LiDAR Quality Assessment Report

AL_BlountCounty_2010-2011

The Atlantic Group

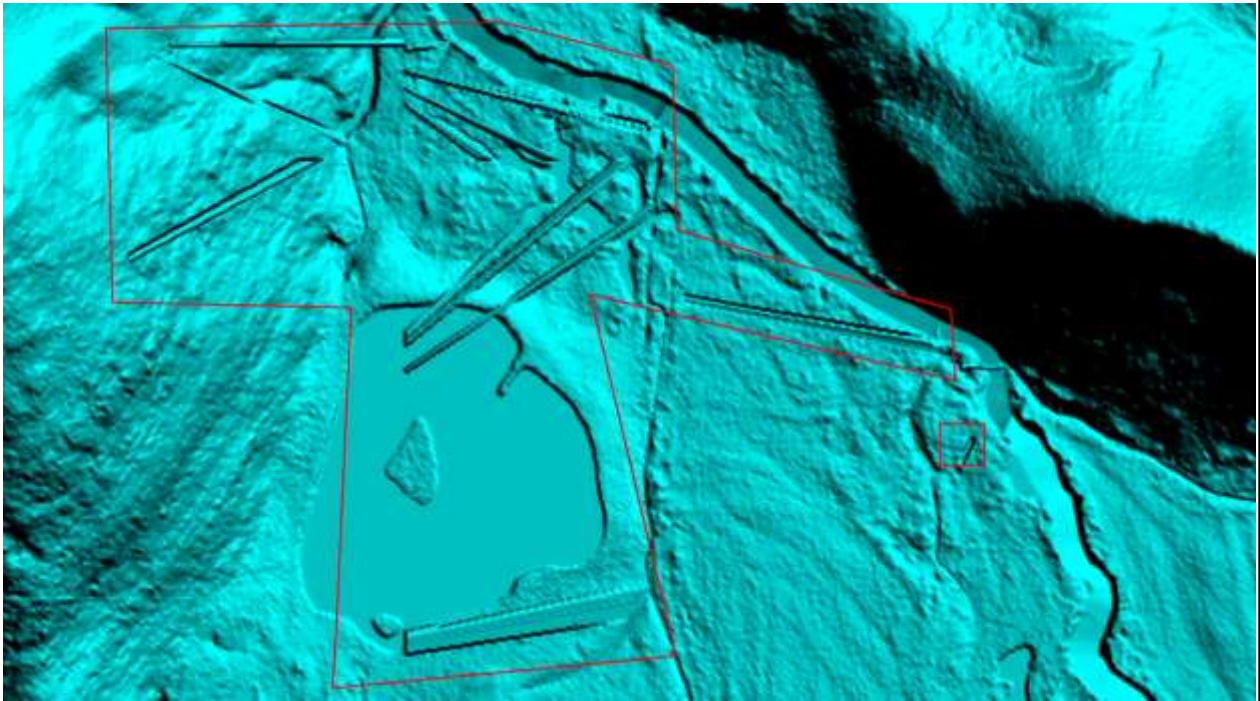
Errors such as these are endemic on streams throughout the DEM

corrected by vendor

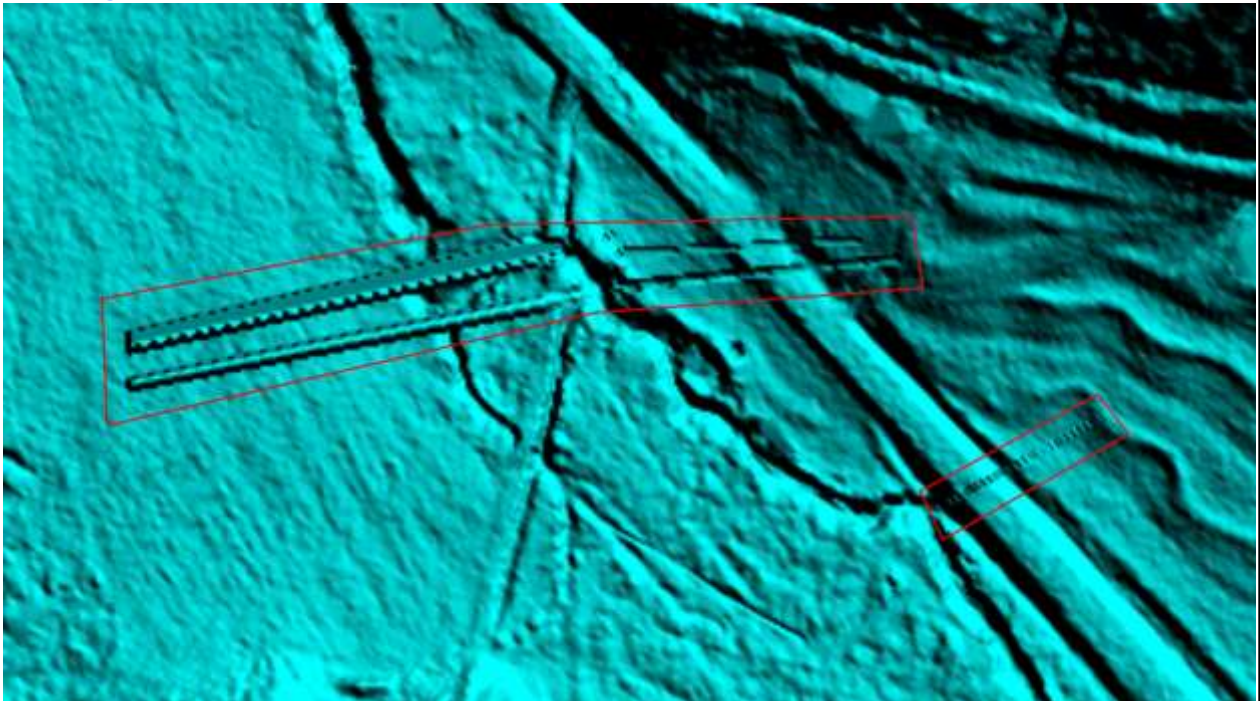
Ground Anomalies such as these were found scattered throughout the DEM.
Location: 33° 59' 58.0701" N, 86° 26' 39.9903" W

corrected by vendor

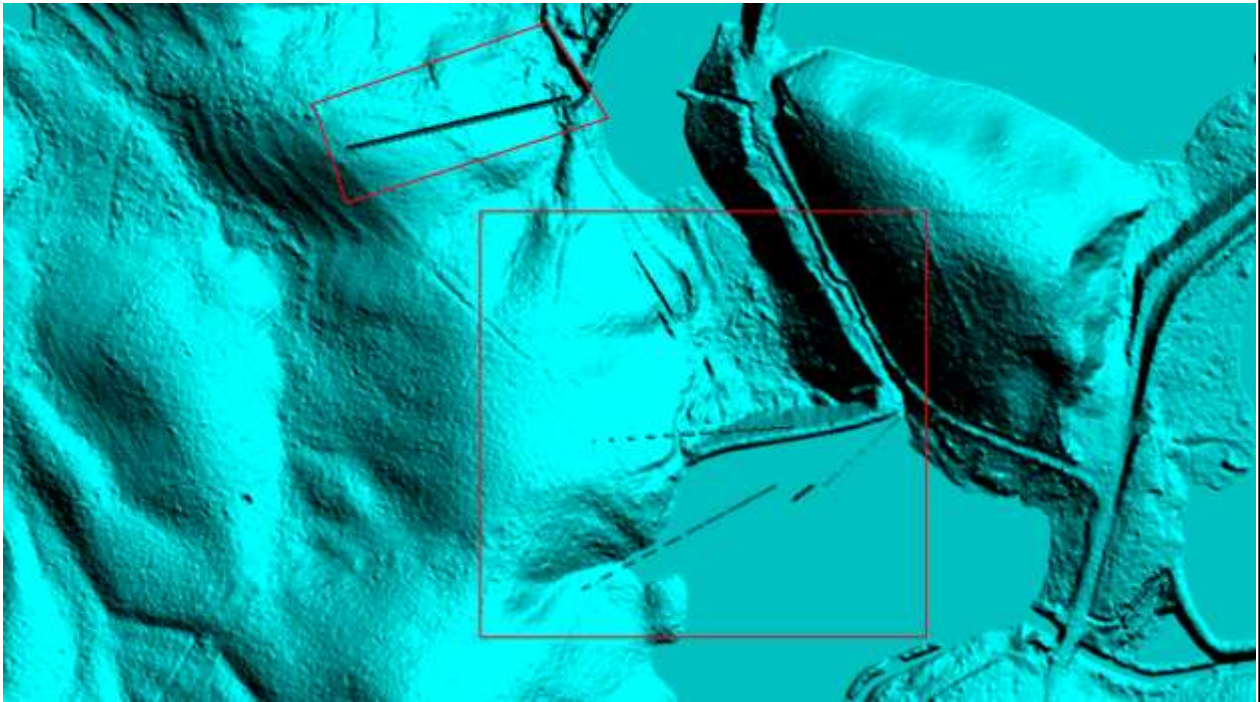
Ground anomaly example at 34° 00' 7.4437" N, 86° 26' 31.6982" W

corrected by vendor

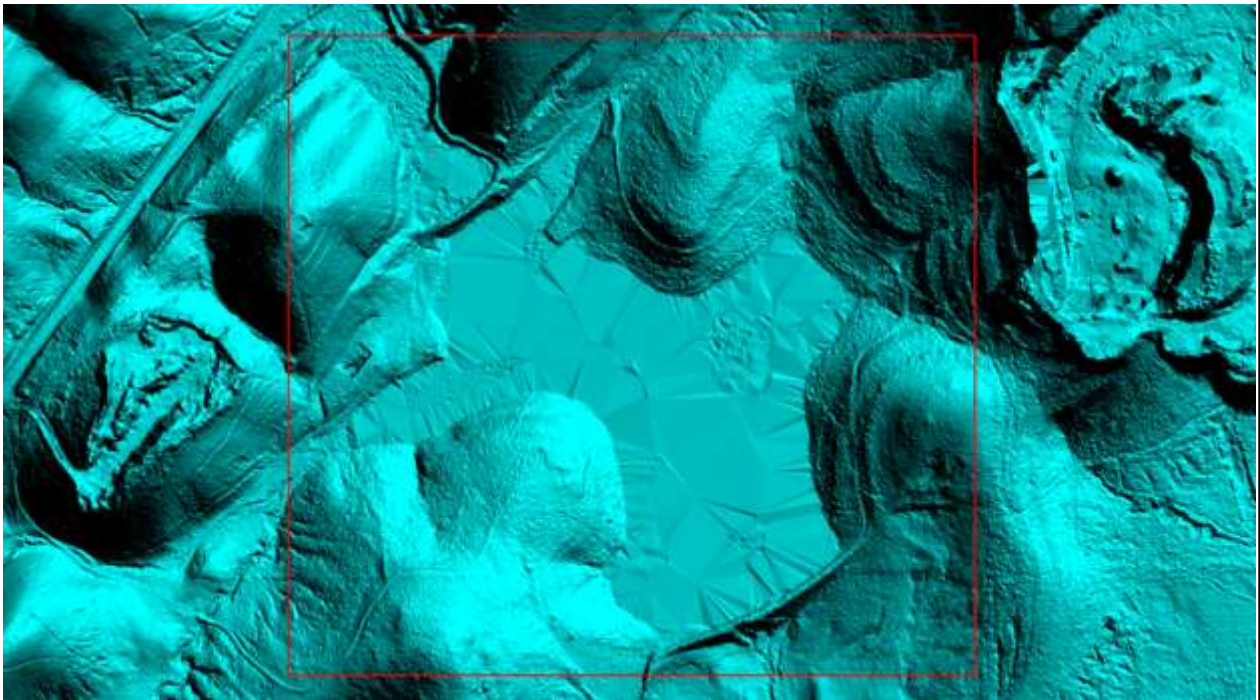
Ground anomaly example at $33^{\circ} 57' 12.5889''$ N, $86^{\circ} 26' 27.8465''$ W

corrected by vendor

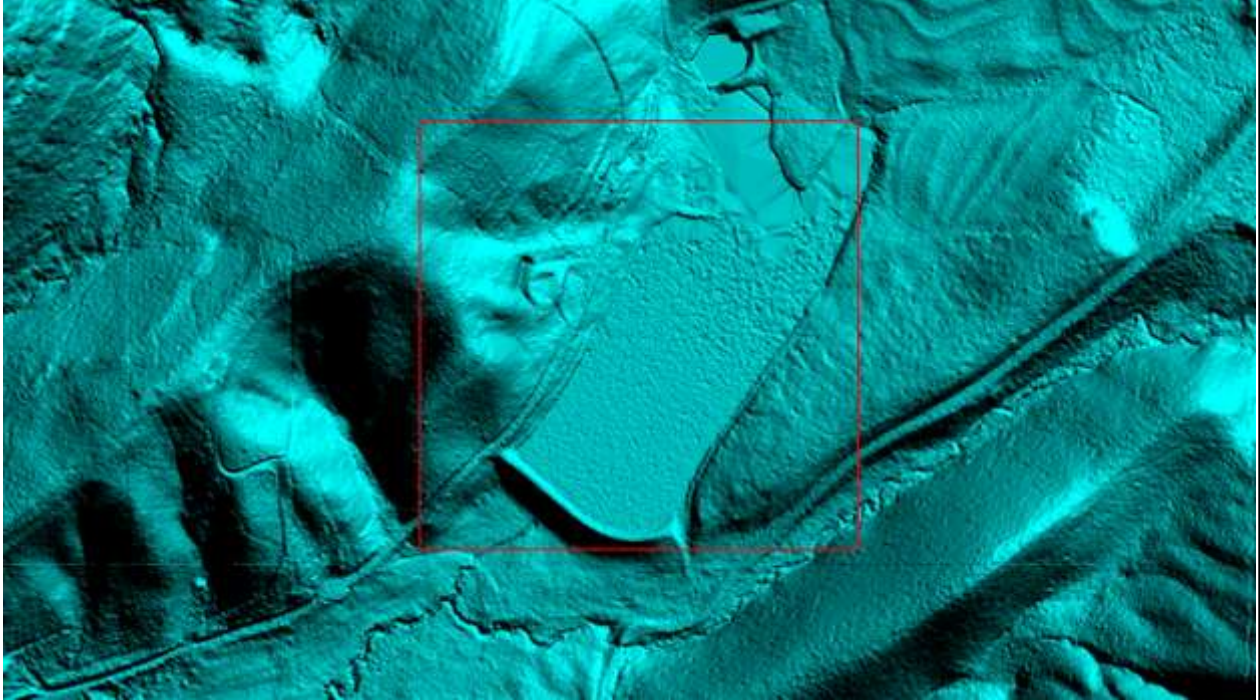
Hydro-flattening error example at $34^{\circ} 11' 19.7709''$ N, $86^{\circ} 29' 40.6400''$ W
corrected by vendor

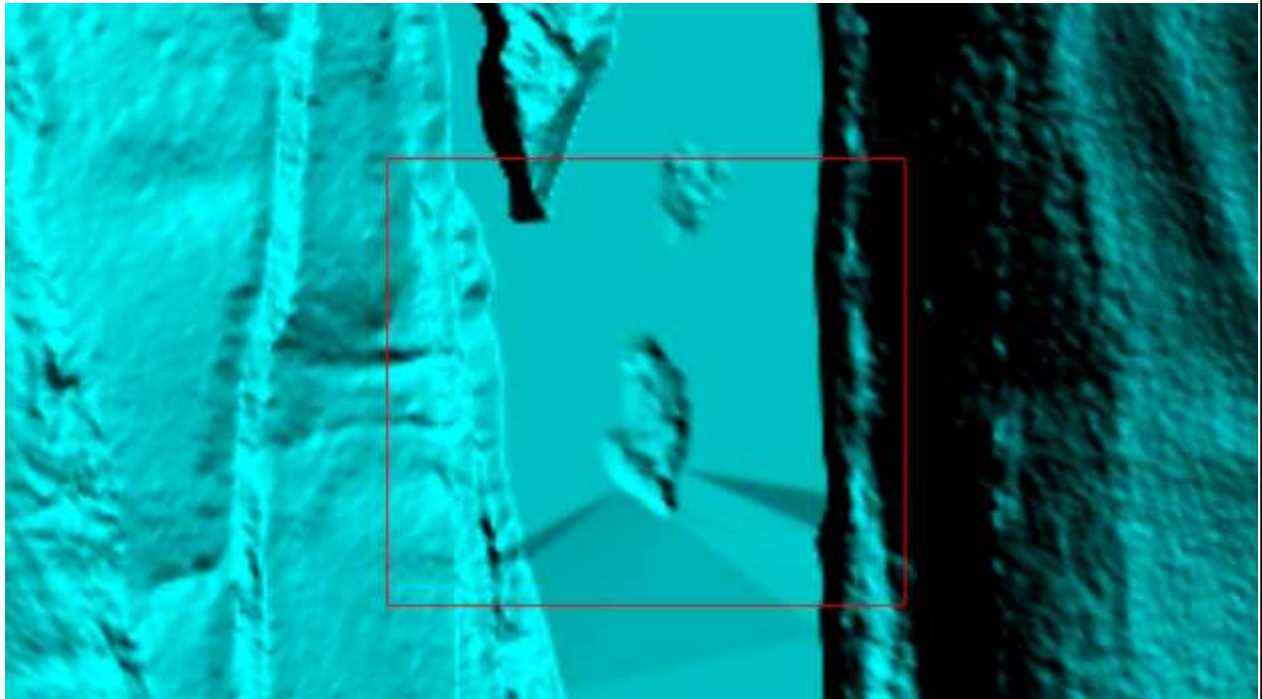
Hydro-flattening error example at $33^{\circ} 58' 19.1366''$ N, $86^{\circ} 27' 53.1278''$ W
corrected by vendor

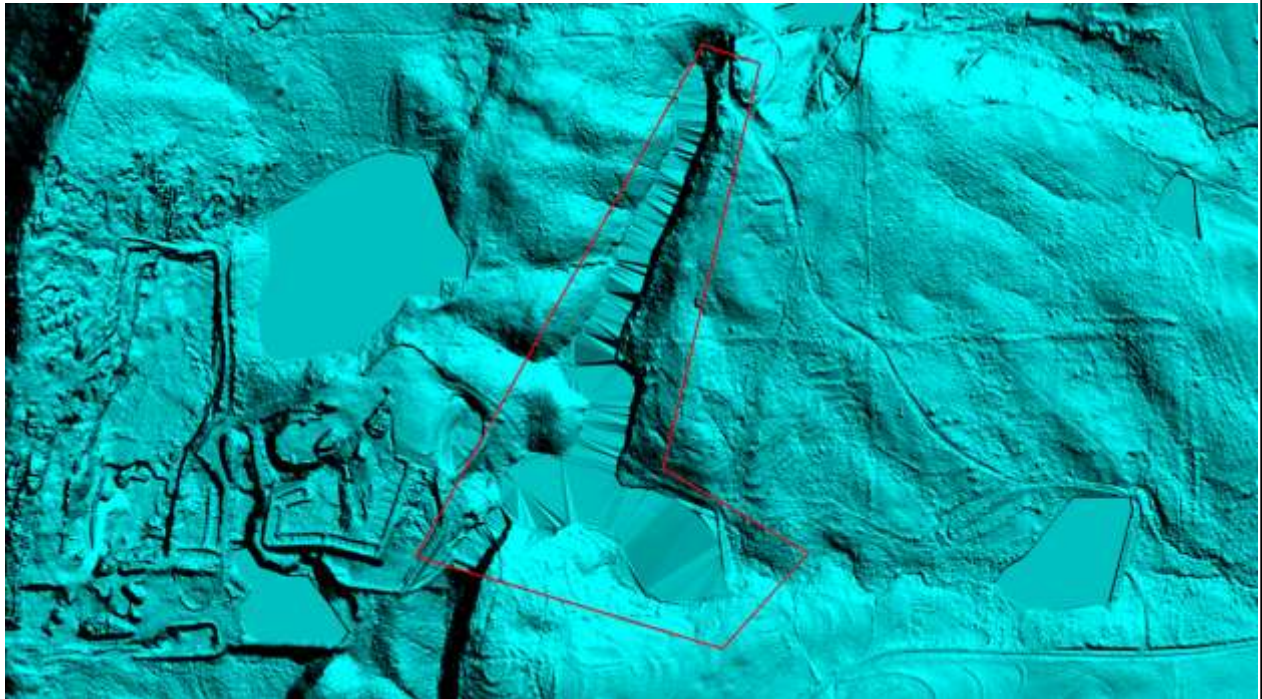
Hydro-flattening error at 33° 58' 39.6841" N, 86° 36' 54.6783" W

corrected by vendor

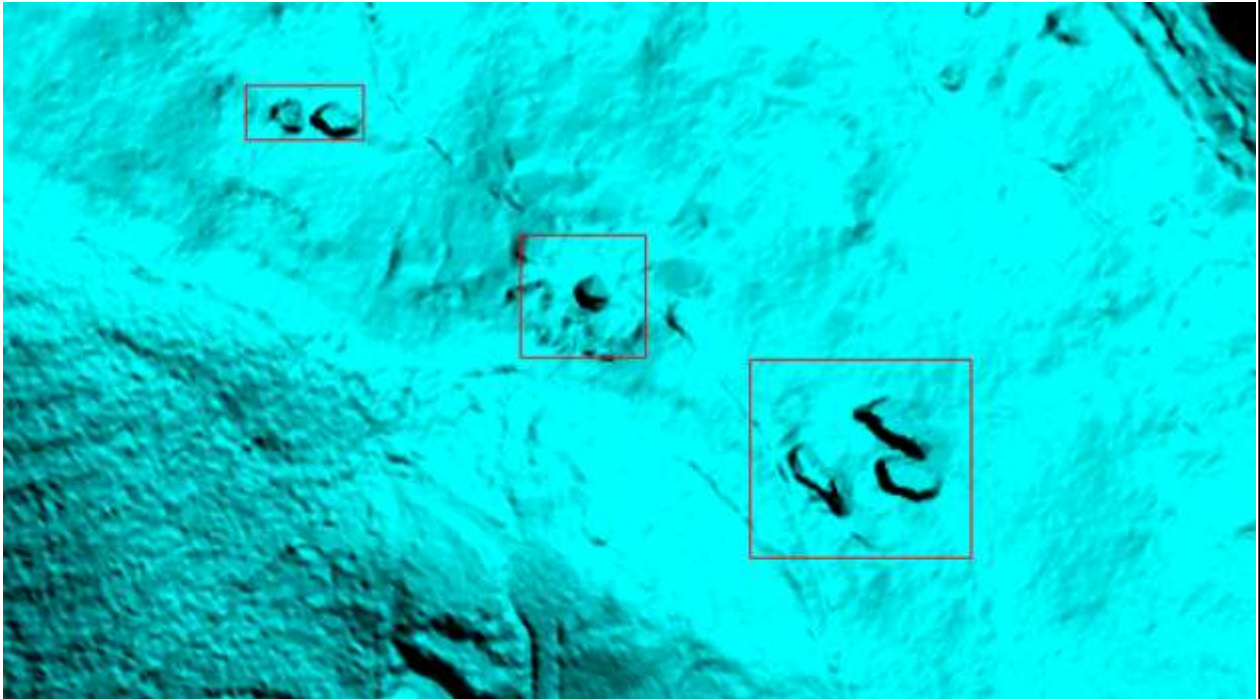
Hydro-flattening error at 34° 09' 41.1899" N, 86° 26' 44.3888" W

corrected by vendor

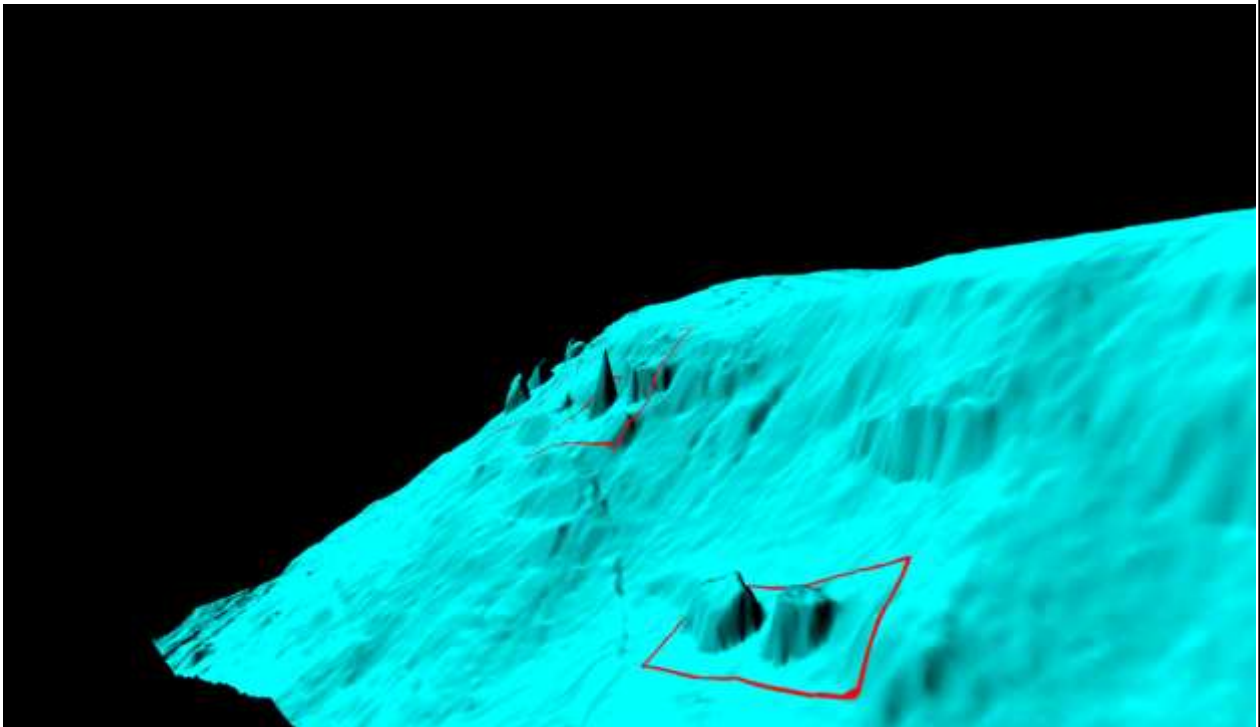
Spikes in terrain at $33^{\circ} 58' 56.9366''$ N, $86^{\circ} 40' 21.9491''$ W

corrected by vendor

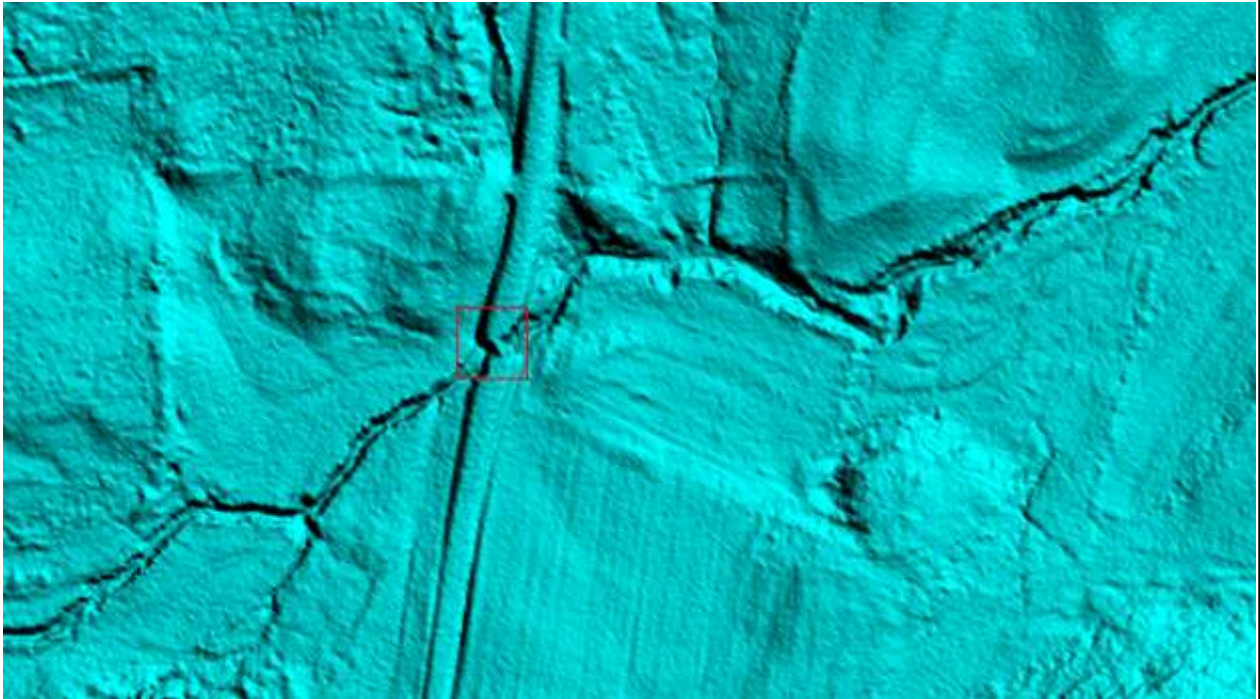
Terrain spikes 3D

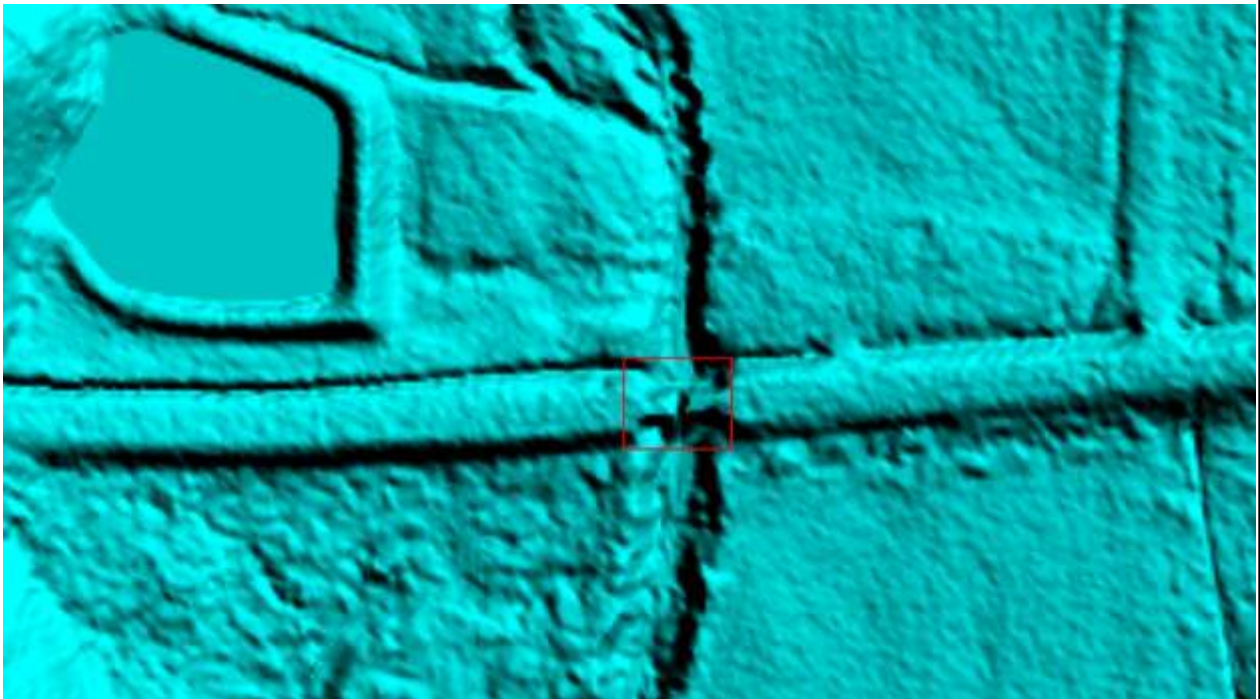
Bridge removal error at $34^{\circ} 11' 4.6748''$ N, $86^{\circ} 29' 11.0990''$ W

corrected by vendor

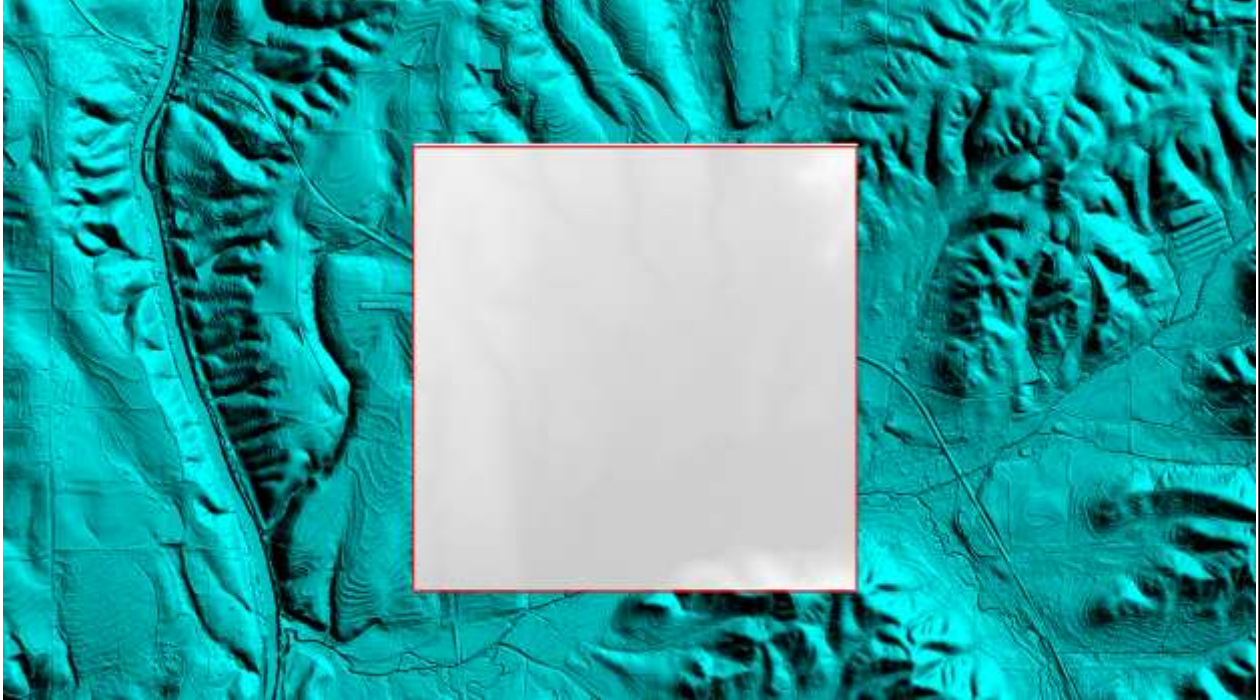
Bridge removal error at 33° 59' 26.3216" N, 86° 33' 59.0608" W

corrected by vendor
